# Access Compliance Report

### (Curb Ramps)

Intersection ID: 48999	Main Street: STEELECROFT_FARM_LN	Cross Street: STEELECROFT_PY	Location:	N
ADA ID: 4BEADF53EC96	Ramp Type: MedianPerp	Initial Pass/Fail: Fail	Overall Compliance: No	Severity Score: 12.5
Codes/Mitigation Info/Possible Solution		Field Measurements/Component Compliance

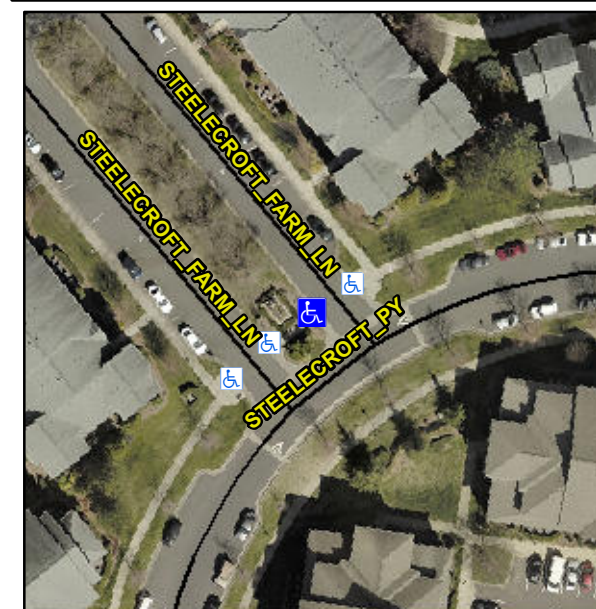
**Remove & Replace Entire Ramp.**

**Not Found, R304.2.2**
